SUBJECT: ISSUANCE OF TECHNICAL SPECIFICATION AMENDMENTS FOR THE BROWNS FERRY
NUCLEAR PLANT UNITS 1 AND 3 (TAC NOS. M82650 AND M82652) (TS-300)

The Commission has issued the enclosed Amendment Nos. 206 and 179 to Facility
Operating License Nos. DPR-33 and DPR-68 for the Browns Ferry Nuclear Plant
(BFN), Units 1 and 3, respectively. These amendments revise the Technical
Specifications (TS) in response to your application dated January 14, 1992.

Amendment No. 206
License No. DPR-33

Amendment No. 179
License No. DPR-68

Figure 3.5.M-1
BFN Power/Flow Stability Regions

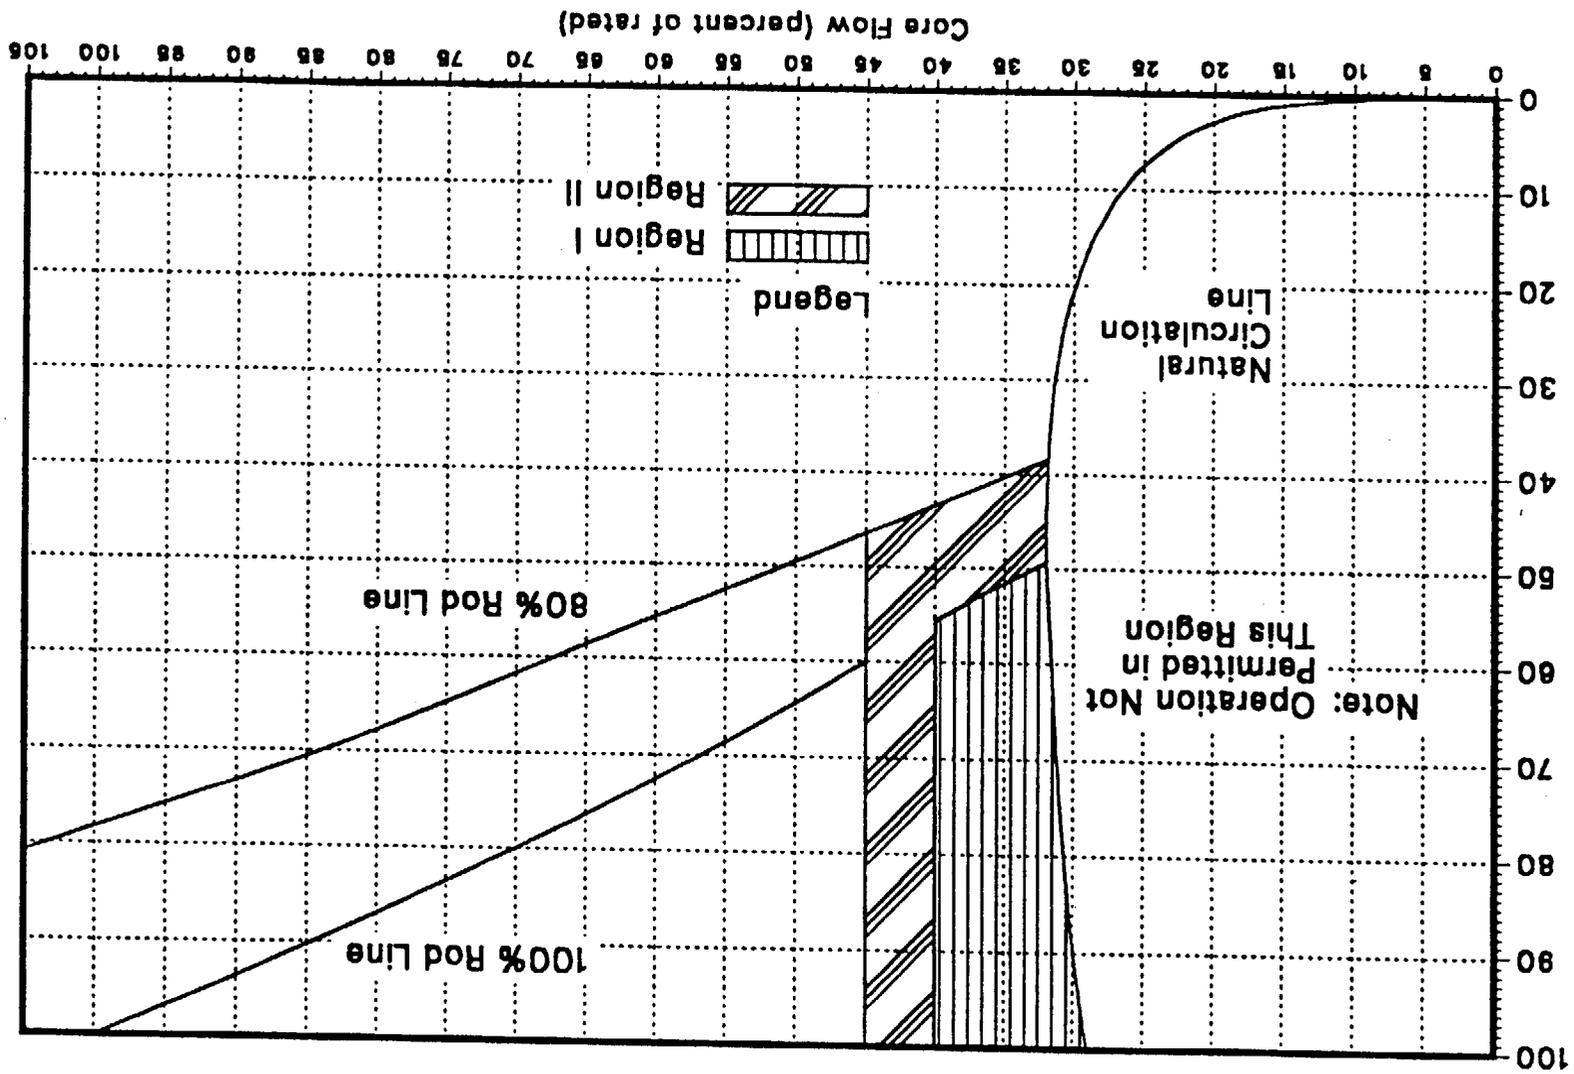
1. The reactor shall not be operated at a thermal power and core flow inside of Regions I and II of Figure 3.5.M-1.
2. If Region I of Figure 3.5.M-1 is entered, immediately initiate a manual scram.
3. If Region II of Figure 3.5.M-1 is entered:
 - a. Immediately initiate action and exit the region within 2 hours by inserting control rods or by increasing core flow (starting a recirculation pump to exit the region is not an appropriate action), and
 - b. While exiting the region, immediately initiate a manual scram if thermal-hydraulic instability is observed, as evidenced by APRM oscillations which exceed 10 percent peak-to-peak of rated or LPRM oscillations which exceed 30 percent peak-to-peak of scale. If periodic LPRM upscale or downscale alarms occur, immediately check the APRM's and individual LPRM's for evidence of thermal-hydraulic instability.

1. Verify that the reactor is outside of Region I and II of Figure 3.5.M-1:
 - a. Following any increase of more than 5% rated thermal power while initial core flow is less than 45% of rated, and
 - b. Following any decrease of more than 10% rated core flow while initial thermal power is greater than 40% of rated.

The minimum margin to the onset of thermal-hydraulic instability occurs in Region I of Figure 3.5.M-1. A manually initiated scram upon entry into this region is sufficient to preclude core oscillations which could challenge the MCPR safety limit.

Because the probability of thermal-hydraulic oscillations is lower and the margin to the MCPR safety limit is greater in Region II than in Region I of Figure 3.5.M-1, an immediate scram upon entry into the region is not necessary. However, in order to minimize the probability of core instability following entry into Region II, the operator will take immediate action to exit the region. Although formal surveillances are not performed while exiting Region II (delaying exit for surveillances is undesirable), an immediate manual scram will be initiated if evidence of thermal-hydraulic instability is observed.

The proposed BFN Units 1 and 3 TS conservatively implement these region designations and associated operation requirements by adding a new specification, TS 3/4.5.M, Core Thermal-Hydraulic Stability, and a power-flow map, Figure 3.5.M-1. The regions designated in Figure 3.5.M-1 are the same as in IRSA, except that regions B and C are combined into a single Region II, with region A designated Region I. The IRSA operating restrictions of Region B are conservatively applied throughout Region II. There is no allowed operation such as is permitted by IRSA, such as for startup in Region C. TS 3.5.M.1, 3.5.M.2, and 3.5.M.3 specify that operation is not permitted in Regions I and II. Upon inadvertent entry, a reactor scram is required if in Region I, and immediate action to depart by control rod insertion or flow increase is required for Region II. While exiting Region II, scram is required if there are indications of instability as evidenced by APRM oscillations above 10 percent peak-to-peak of rated power or LPRM oscillations above 30 percent, and LPRM upscale or downscale alarms require immediate checks of APRM and LPRM readings. These requirements all meet or exceed the IRSA specifications, and are acceptable for meeting the bulletin requests for implementing the interim recommendations. TS 4.5.M provides appropriate surveillance requirements for determining that operation is outside of Regions I and II when operating in the vicinity of these regions, and are also acceptable. The new Bases 3.5.M provides a reasonable discussion of the

Figure 3.5.M-1
BFN Power/Flow Stability Regions

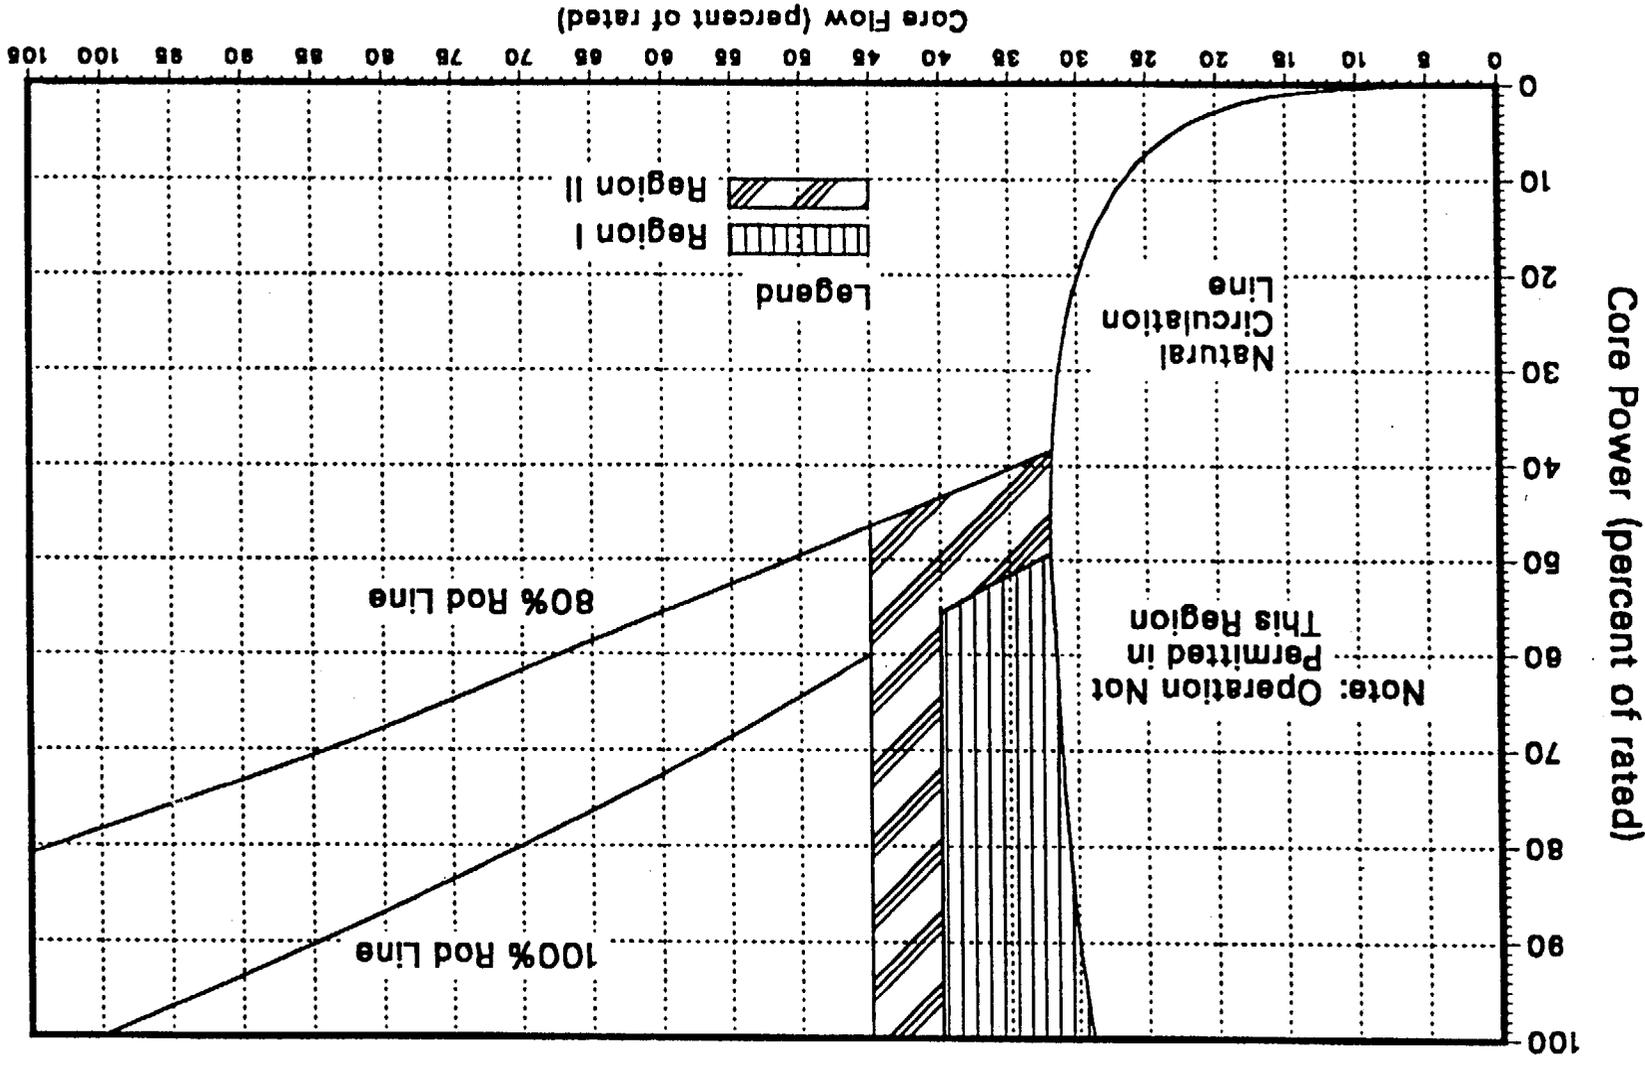
1. The reactor shall not be operated at a thermal power and core flow inside of Regions I and II of Figure 3.5.M-1.
2. If Region I of Figure 3.5.M-1 is entered, immediately initiate a manual scram.
3. If Region II of Figure 3.5.M-1 is entered:
 - a. Immediately initiate action and exit the region within 2 hours by inserting control rods or by increasing core flow (starting a recirculation pump to exit the region is not an appropriate action), and
 - b. While exiting the region, immediately initiate a manual scram if thermal-hydraulic instability is observed, as evidenced by APRM oscillations which exceed 10 percent peak-to-peak of rated or LPRM oscillations which exceed 30 percent peak-to-peak of scale. If periodic LPRM upscale or downscale alarms occur, immediately check the APRM's and individual LPRM's for evidence of thermal-hydraulic instability.

1. Verify that the reactor is outside of Region I and II of Figure 3.5.M-1:
 - a. Following any increase of more than 5% rated thermal power while initial core flow is less than 45% of rated, and
 - b. Following any decrease of more than 10% rated core flow while initial thermal power is greater than 40% of rated.

The minimum margin to the onset of thermal-hydraulic instability occurs in Region I of Figure 3.5.M-1. A manually initiated scram upon entry into this region is sufficient to preclude core oscillations which could challenge the MCPR safety limit.

Because the probability of thermal-hydraulic oscillations is lower and the margin to the MCPR safety limit is greater in Region II than in Region I of Figure 3.5.M-1, an immediate scram upon entry into the region is not necessary. However, in order to minimize the probability of core instability following entry into Region II, the operator will take immediate action to exit the region. Although formal surveillances are not performed while exiting Region II (delaying exit for surveillances is undesirable), an immediate manual scram will be initiated if evidence of thermal-hydraulic instability is observed.
